Utility Plan  
 drawing  
 H.M. Life  
 Opportunity Services  
 project

date	3/21/01
project number	2798
sheet	SD-4

**UTILITY PLAN**  
 SCALE: 1" = 20'-0"  
 SEE DIAG. SD-3 FOR STORM WATER DRAINAGE

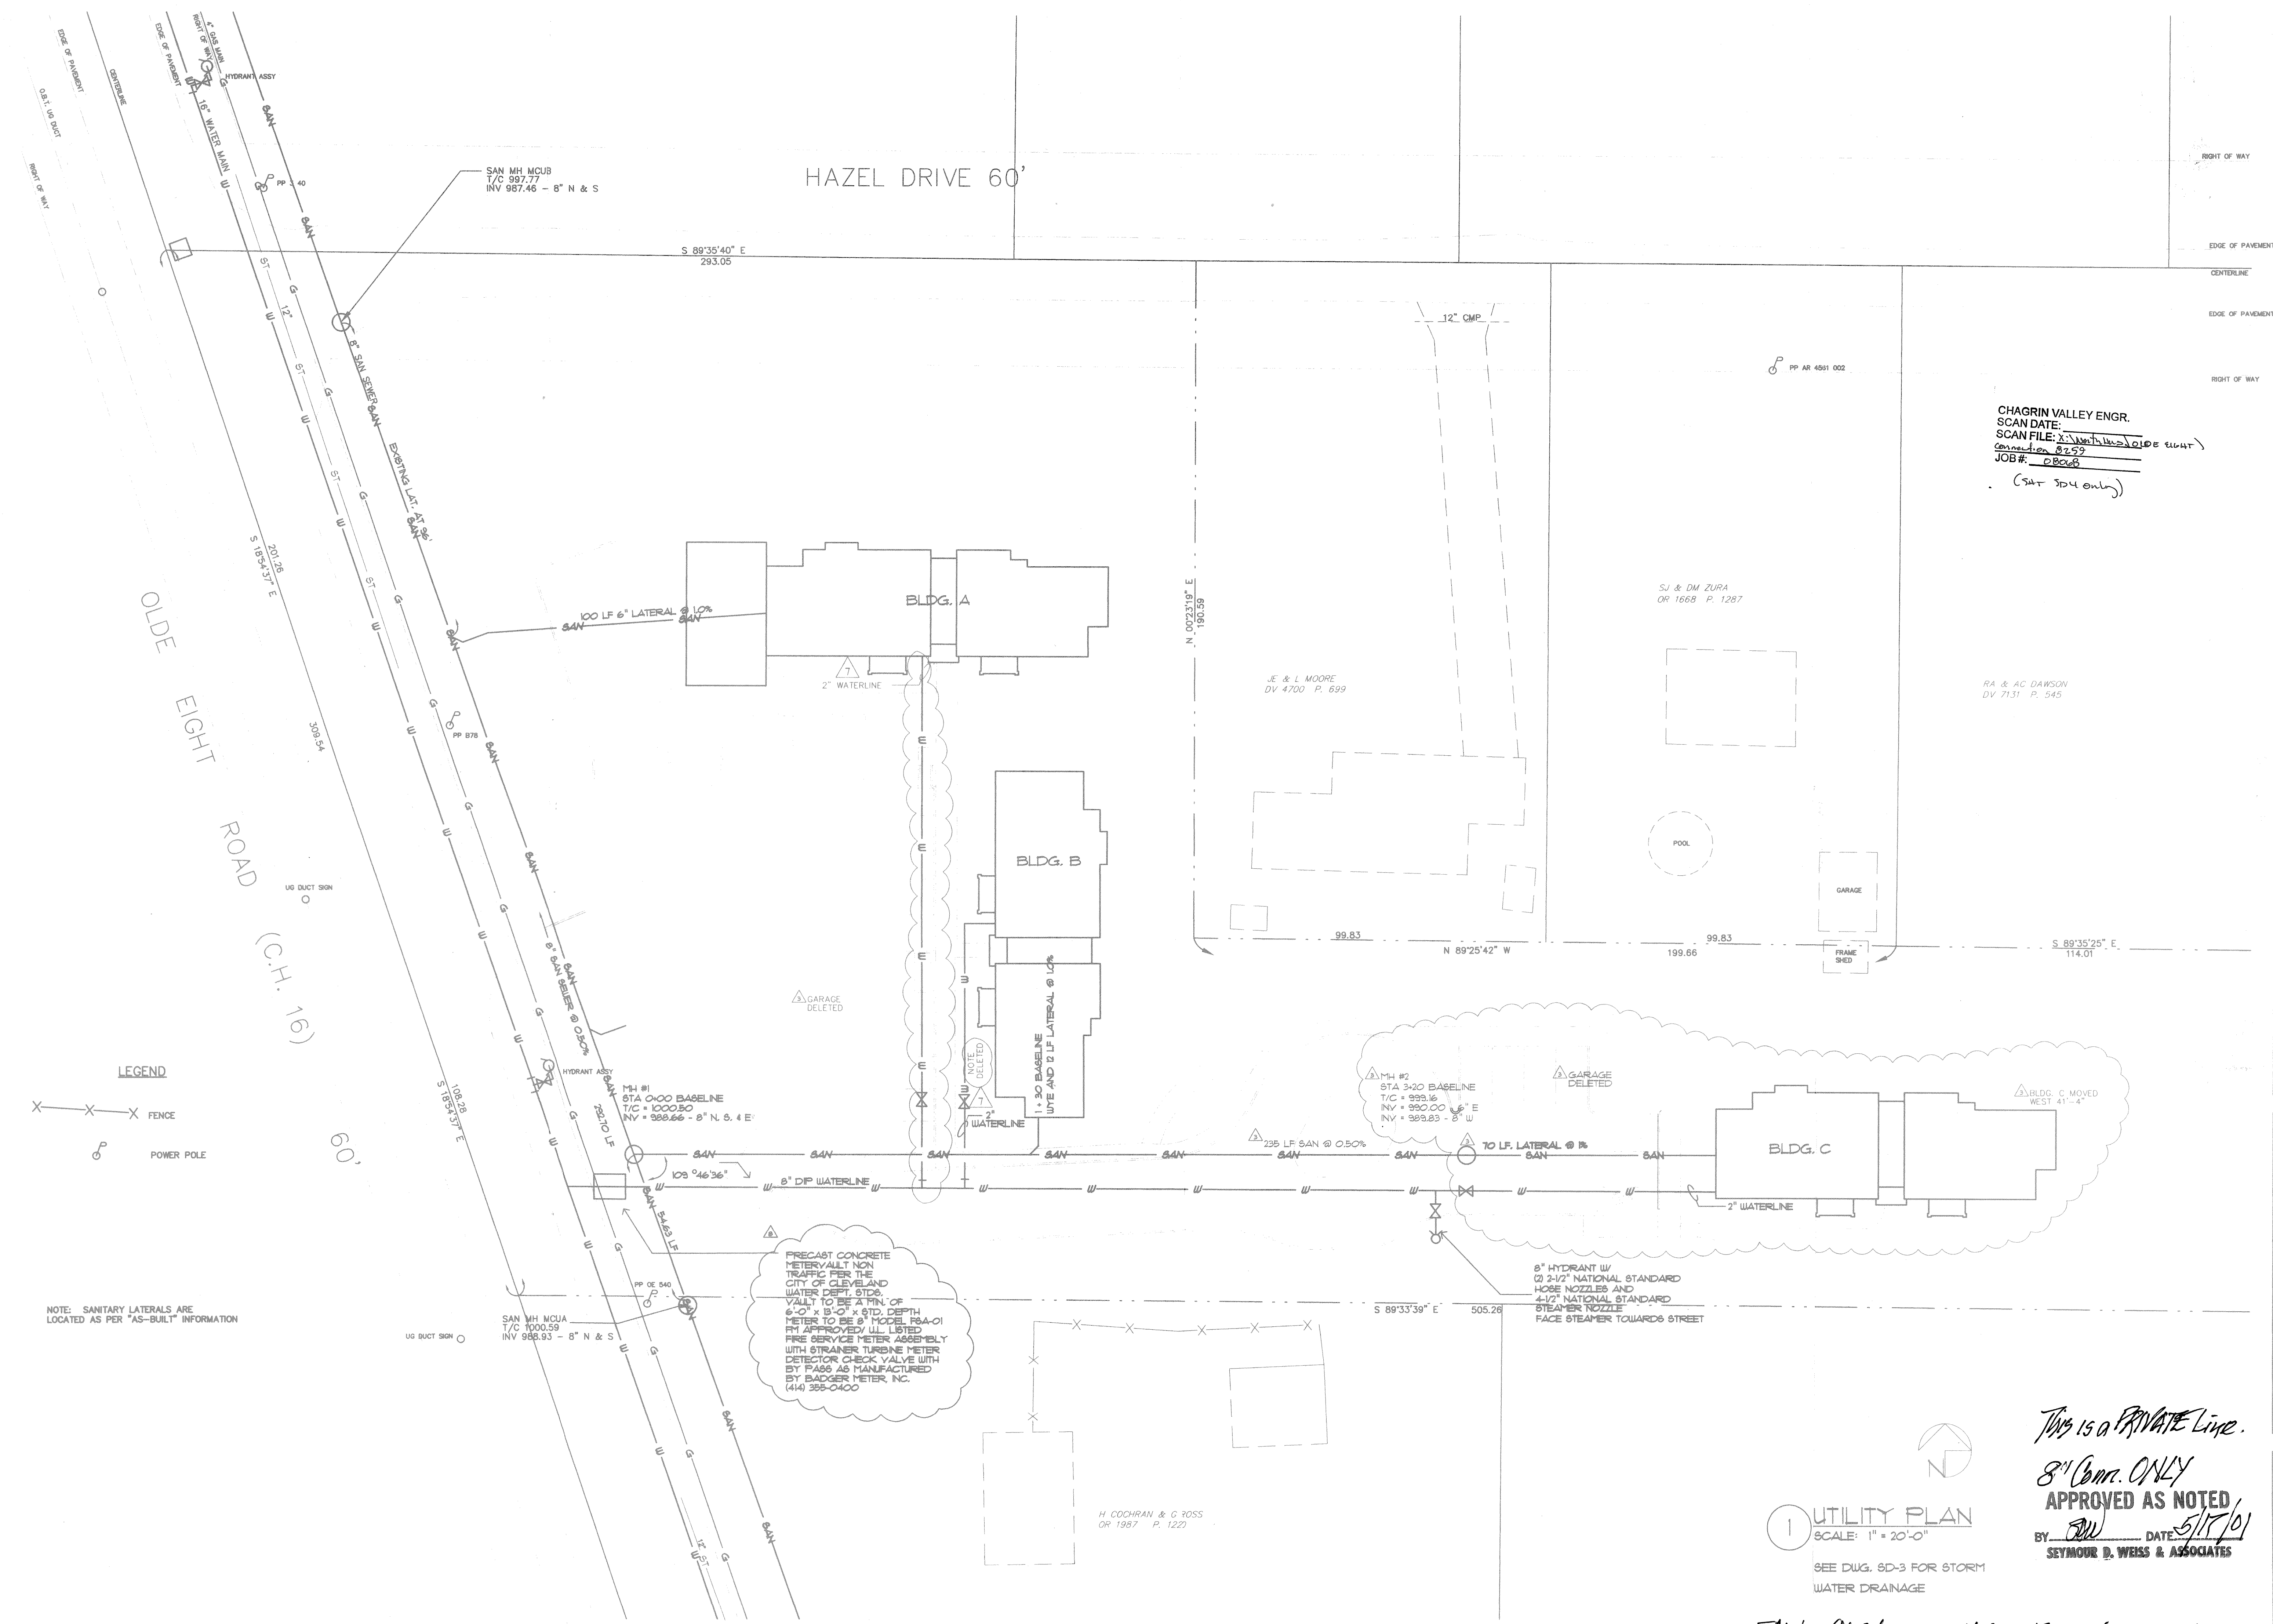
*This is a PRIVATE Line.*  
 8" Conn. ONLY  
**APPROVED AS NOTED**  
 BY *SW* DATE *5/17/01*  
 SEYMOUR D. WEISS & ASSOCIATES
